Subject: *Meadowbrook Park Noise Analysis
Colorado Springs, CO*

Noise V_1 redlines planning.pdf Markup Summary 12-15-2020

Figure 2: Common Noise Levels

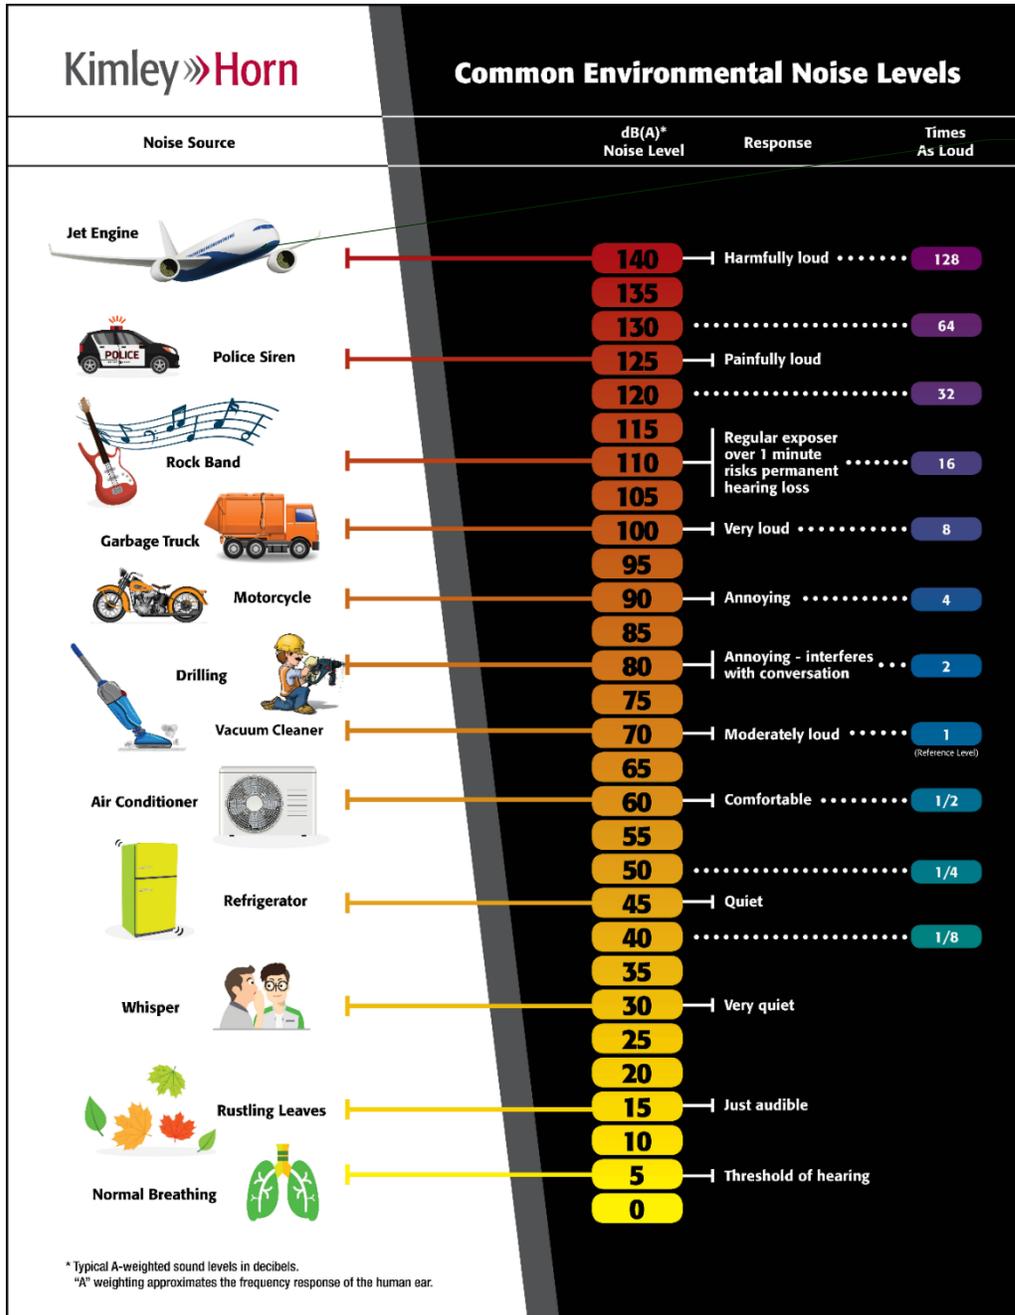
Site is just outside of the airport crash zone, but you didn't address airplane noise and why you have a requirement to reduce interior noise to 30db on PUD??
